Technical Service Bulletin: tsb103847

New Lubricating Oil Cooler Mounting Stud Gasket

This Service/Parts Topic introduces a new lubricating oil cooler mounting stud gasket for Industrial and Power Generator QSK45, QSK60, and QSK78 engines.

Old Paper Oil Cooler Stud Gasket, Part Number 3630969 (left) and New Edge-mounted Oil Cooler Stud Gasket, Part Number 3637730 (right)

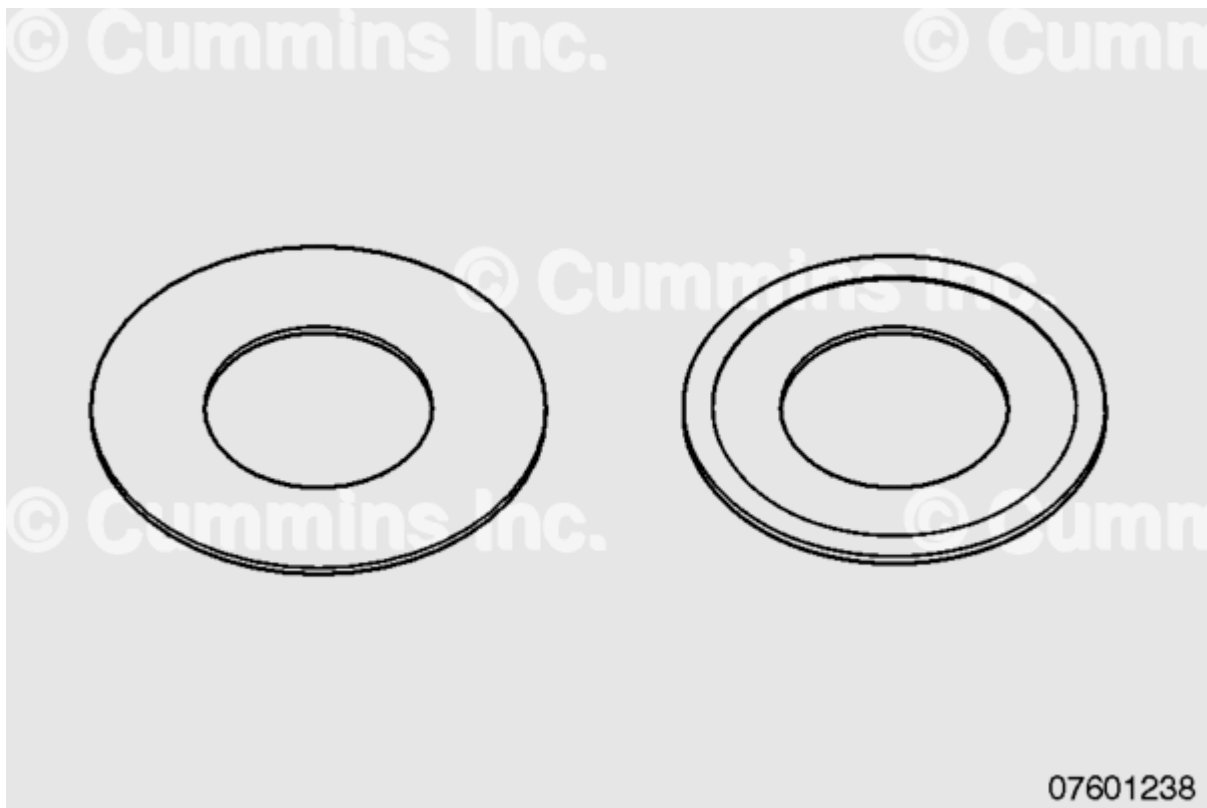
The new gasket is an edge-molded gasket which has improved sealing capability.

The new oil cooler stud gasket, Part Number 3637730, replaces the oil cooler stud gasket, Part Number 3630969, on **all** QSK45, QSK60, and QSK78 engines. **Only** use a new oil cooler stud gasket, Part Number 3637730, for repairs.

The old oil cooler stud gasket, Part Number 3630969, is a paper gasket. The new gasket is an edge-molded gasket.

During installation, use Loctite™ 271, Part Number 3375968, sparingly on the oil cooler stud threads.
